ADDENDUM NO. 2

December 9, 2022

BAILLY ELEMENTARY SCHOOL ADDITIONS AND RENOVATIONS Chesterton, IN 46304

Addendum Two (AD.02) to the drawings and specifications prepared by Gibraltar Design for **Bailly Elementary School Renovations** for Duneland School Corporation, Chesterton, Indiana.

AD103

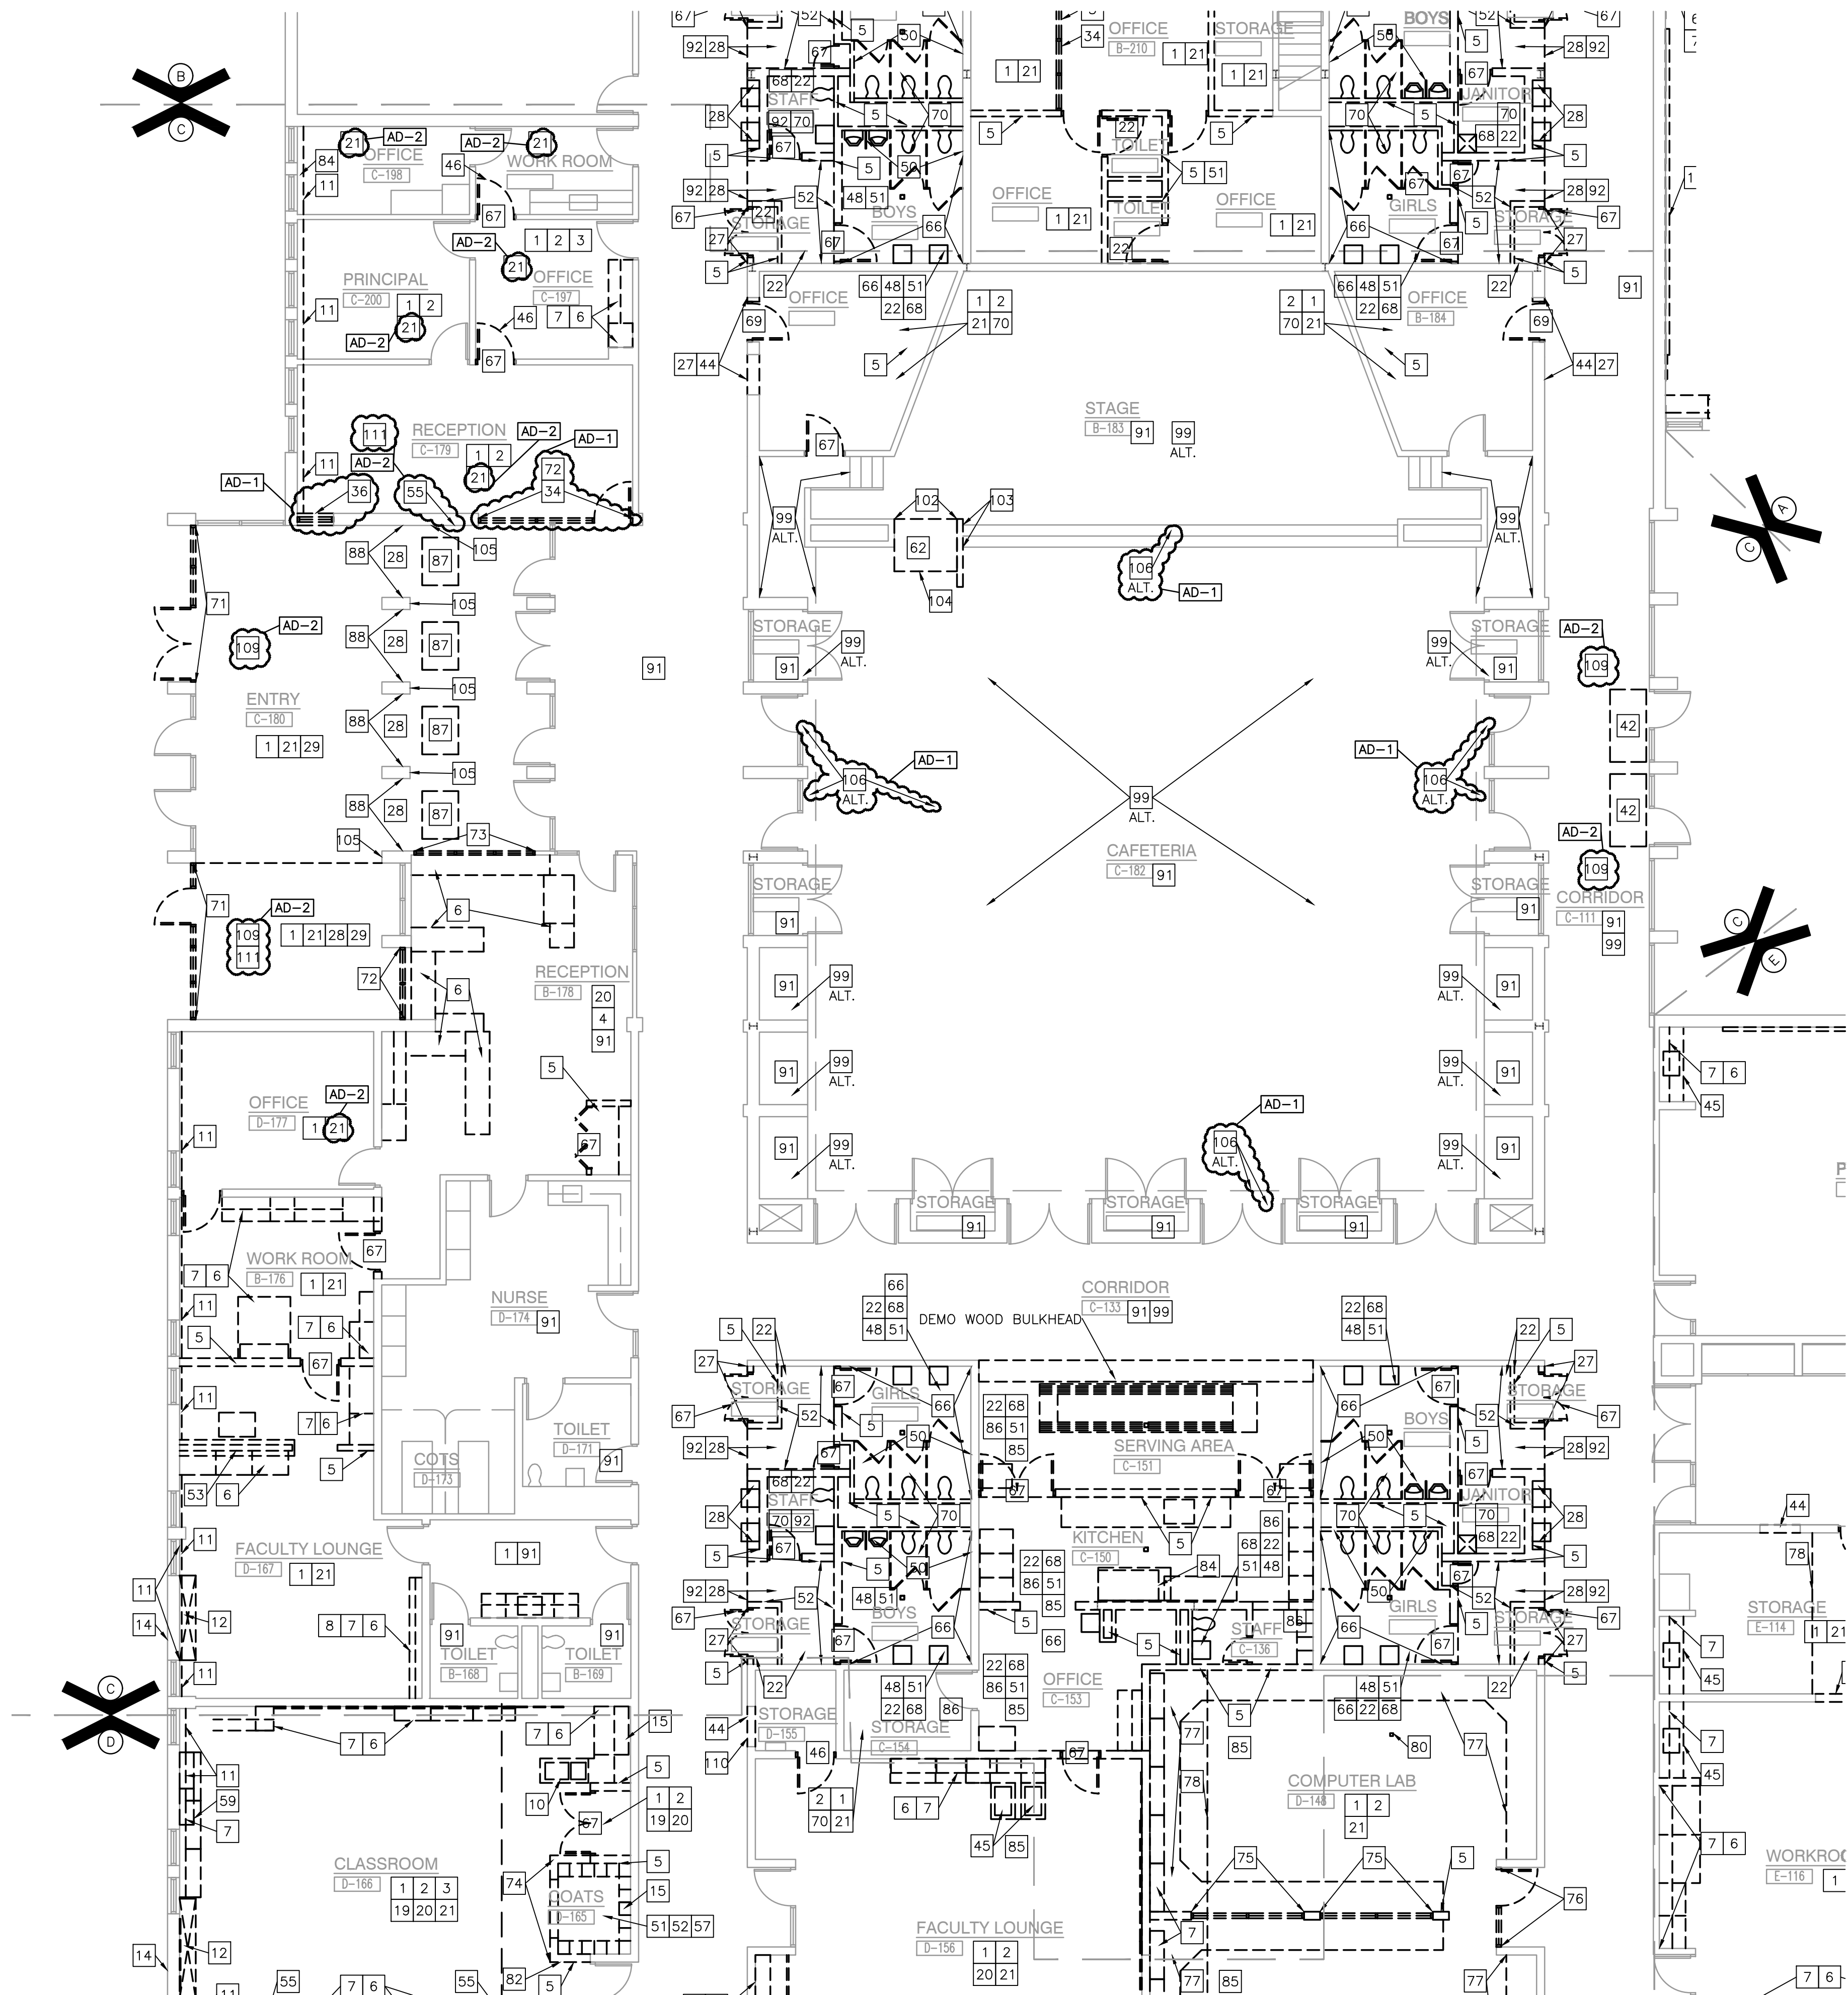
- A. Refer to revised full size drawing included in this addendum for the following revisions:
1. Add Plan Notes 55 and 109 to C-180 Entry clarifying ceiling and wall mounted cabinet heaters.

2. Add Plan Notes 109 to C-111 Corridor clarifying cabinet heater in ceiling.
3. Add Plan Note 111 to C-180 Entry and C-179 for recessed floor devices.
4. Update to indicate Plan Note 21 in the following rooms for removal of existing ceiling: Office C-198, Work Room, Principal C-200, Office C-197, Reception C-179, Office D-177.

UNIT "E" ARCHITECTURAL FIRST FLOOR DEMOLITION PLAN
SCALE: 1/8" = 1'-0"

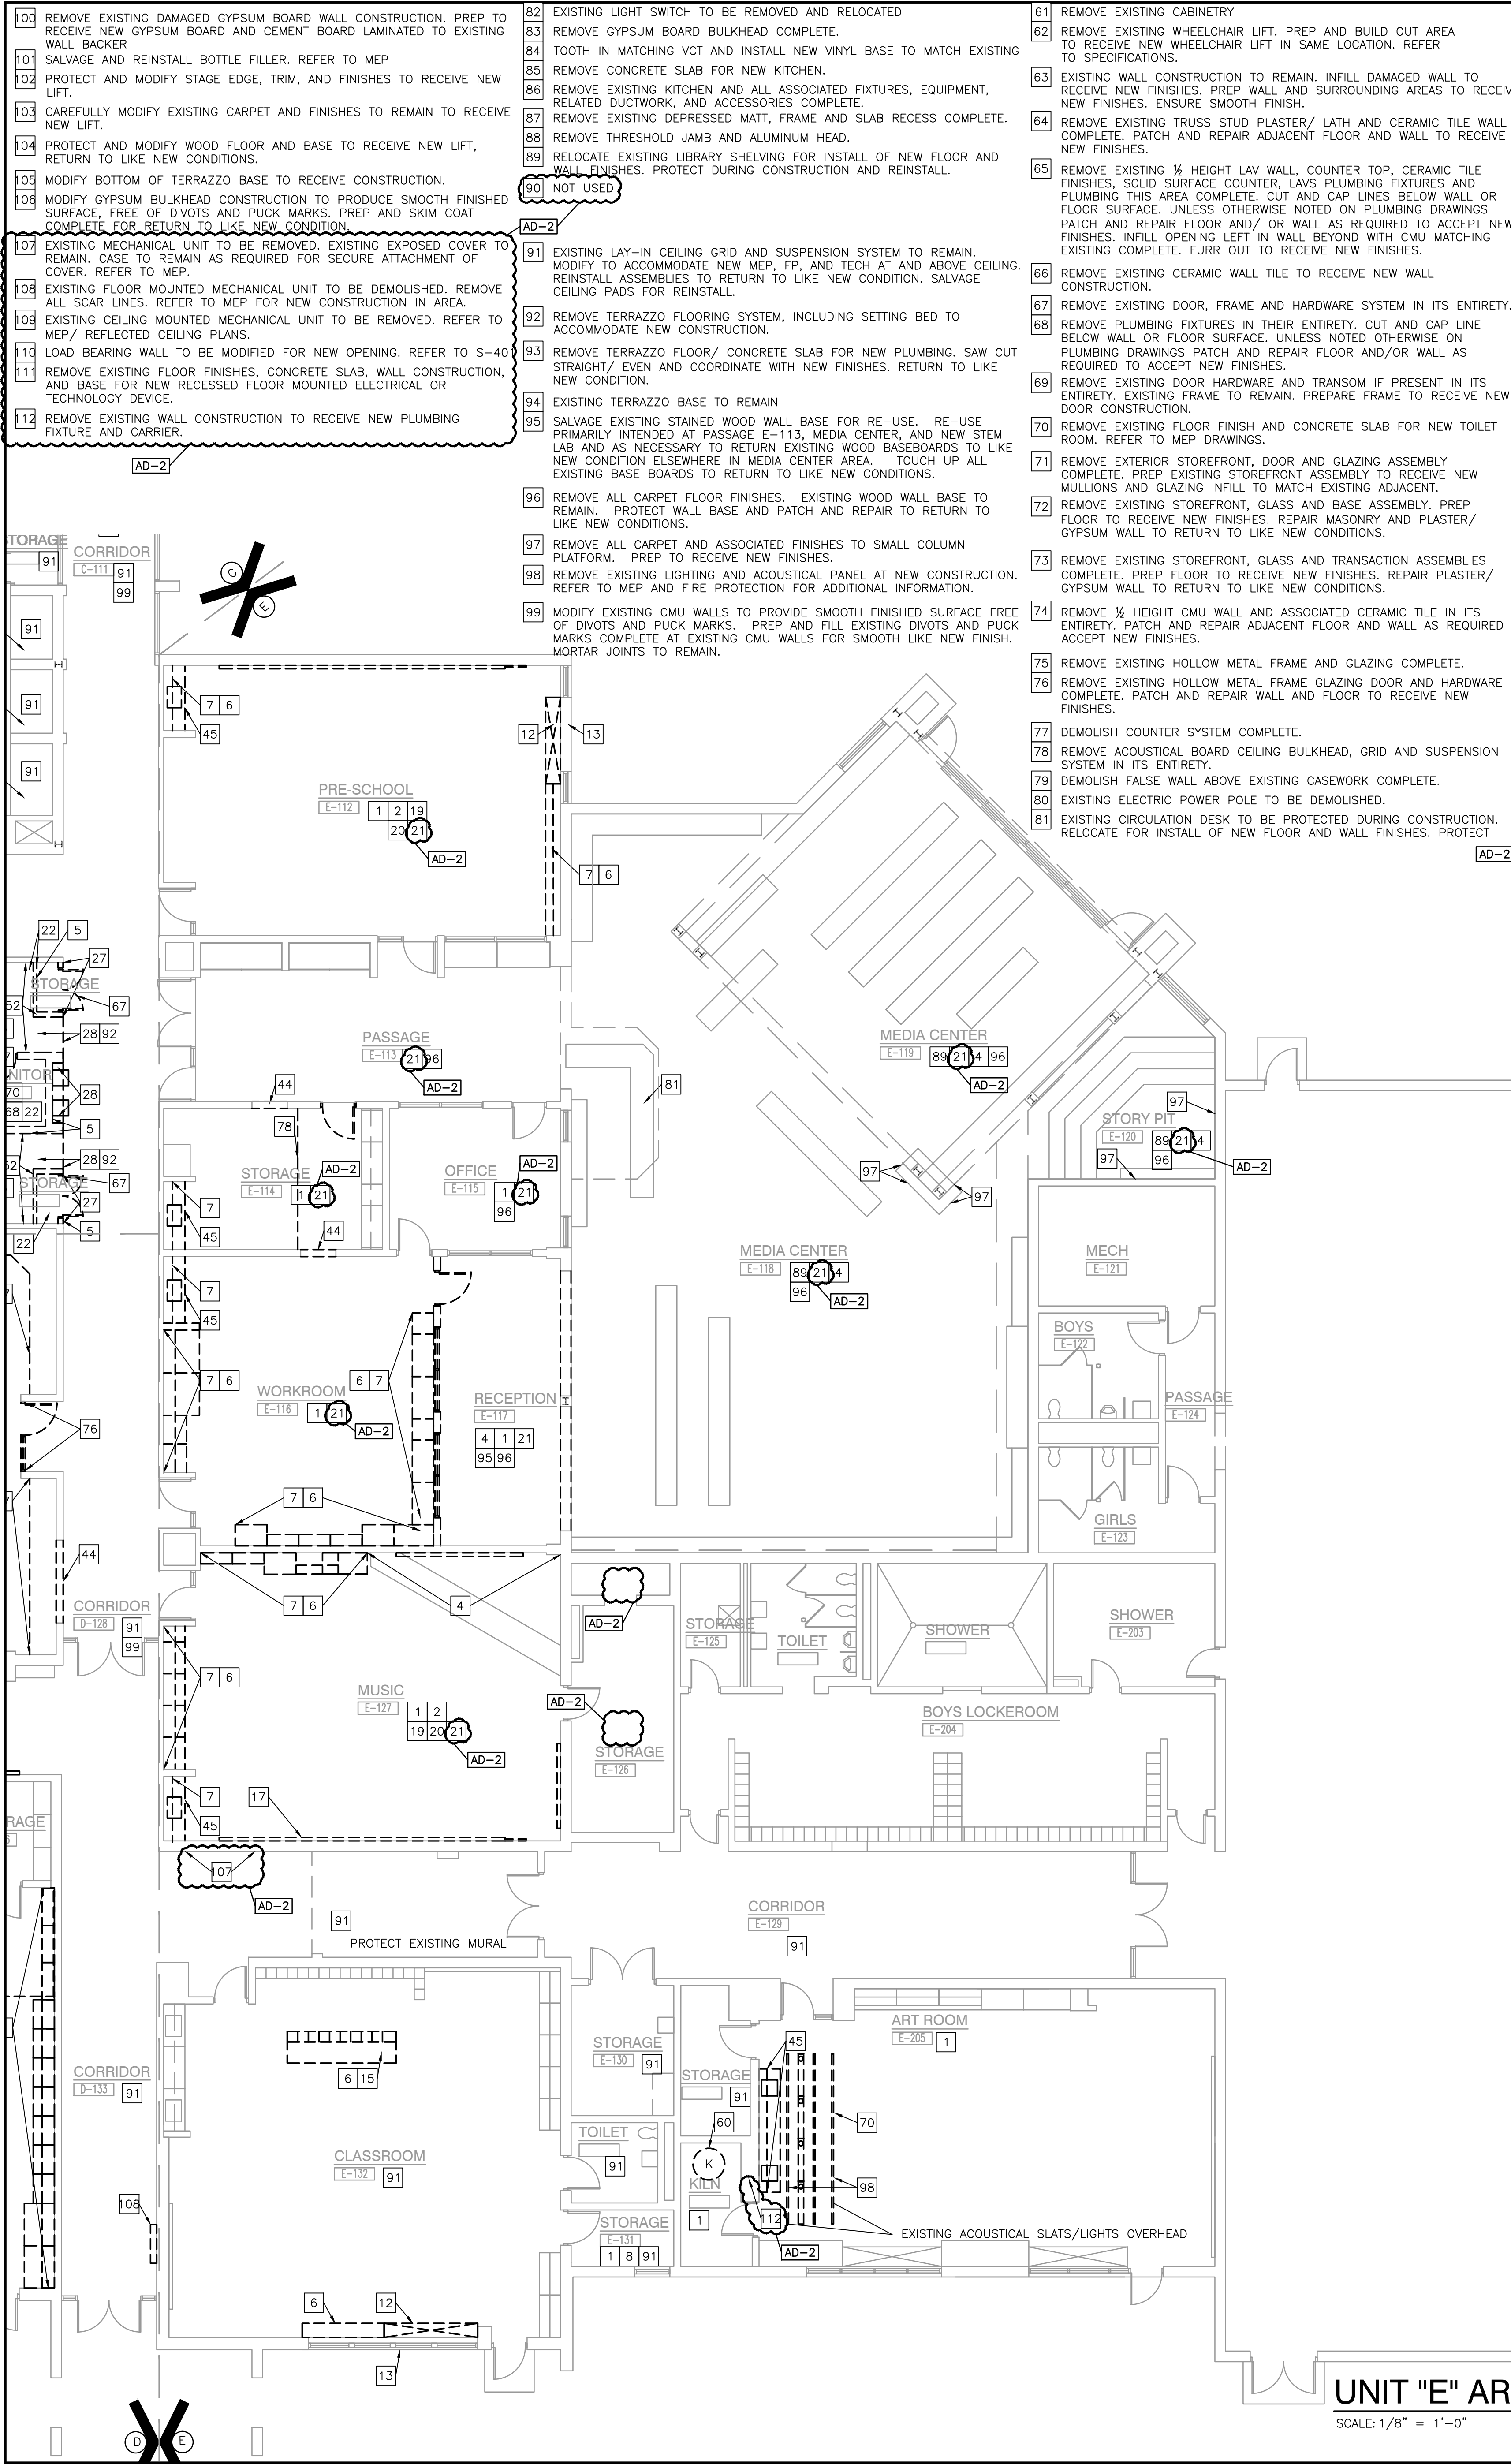
1. Add Plan Note 107 clarifying cabinet heaters.
2. Add Plan Note 112 clarifying wall construction and new plumbing fixture.
3. Update to indicate plan note 21 in the following rooms for removal of existing ceiling: Pre-School E-112, Passage E-113, Storage E-114, Office E-115, Workroom E-116, Media Center E-118, Media Center E-119, Story Pit E-120, Music E-127.
4. Update Storage E-126 as indicated.
